| Intersection ID: 27792 | Main Street: BLAKENEY_HEATH_RD | Cross Street: PARKS_FARM_LN | Location: | NW |
| ADA ID: AA68A4E92669 | Ramp Type: BlendTrans1 | Initial Pass/Fail: Fail | Overall Compliance: No | Severity Score: 8.75 |

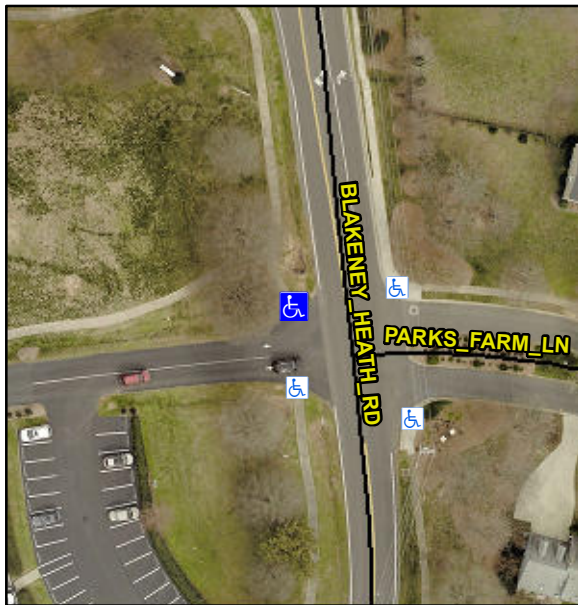
| Compliance | Description | Data | Compliance | Description | Data |
|------------|-----------------------|------|------------|-----------------------------|------|
| No | Ramp Width (in) | 47.0 | Yes | BlendTrans XSlope (%) | 0.7 |

Remove & Replace Curb Ramp With Two New Directional Ramps or Equivalent.
